2016 - 2017 Cadillac ATS-V and CTS-V: GM TechLink: #16-NA-399: Information on Replacing Half Shaft Fasteners with Revised Parts

#16-NA-399: Information on Replacing Half Shaft Fasteners with Revised Parts - (Feb 28, 2017)

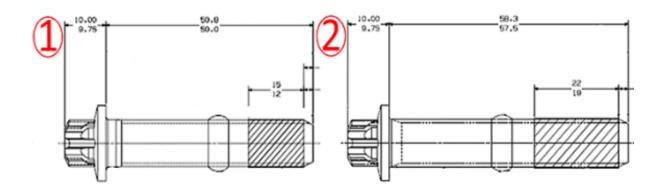
- Three retainer assemblies required per half-shaft.
 - Each retainer assembly consist of 2 longer length bolts (1), 2 lock washers (2) and 1 retainer (3).
 - Where applicable, each axle assembly uses 3 retainer assemblies per side.
 - Replacement of *all* retainer assemblies are required during repair.

Service stock half shafts may include POA retainer assemblies that have the shorter bolt (1), these assemblies may require to be exchanged with new retainer assemblies that have the longer bolts (2).

- Remove and discard retainer assemblies.
- Install new retainer assemblies.
 - Torque bolts to proper torque specifications. Refer to

• The new half shaft bolts must be removed, measured and discarded if the length is incorrect.
